Item ID: D206-642-341BL Accept ***N900040100*** Setup Start ***NS1***
Revision ID: Stop ***NS2***
Item Name: Replacement Skidtube (Fits LH or RH)
Start Date: 5/17/2017 Start Qty: 1.00 ***1*** Cust Item ID:
Required Date: 5/30/2017 Req'd Qty: 1.00 ***1*** Customer:
Reference: SCHEDULED/C

DRAWING NO. D2650	TITLE 206/407 SKIDTUBE ASSEMBLIES	REV. F	DART AEROSPACE LTD ENGINEERING ORDER		D.E.O. NO. D2650-F-1	SHEET NO. SHEET 1 OF 1	SCALE NTS
DRAWN <i>JP</i>	CHECKED <i>A.P.</i>	MFG. APPR. <i>DA</i>	APPROVED <i>TH</i>		DE APPR. <i>TH</i>		
DATE 12.10.12	DATE 12.10.22	DATE 12.10.22	DATE 12.10.22		DATE 12.10.22

CHANGE C'BORED WELDED CROSSBOLT SPACERS TO SWAGED SPACERS

DETAIL B

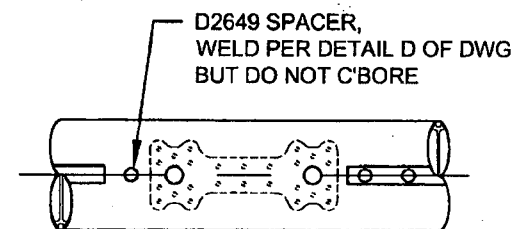
C'BORED HOLES ARE **NOW SWAGED** PER DETAIL G BELOW. FOR THE Ø0.375 HOLE THAT IS NOT C'BORED, WELD PER DETAIL D OF DWG (SEE AMENDED DETAIL B FOR REFERENCE).

ADD DETAIL G BELOW, WHICH IS THE SAME SECTION VIEW AS DETAIL D OF DWG.
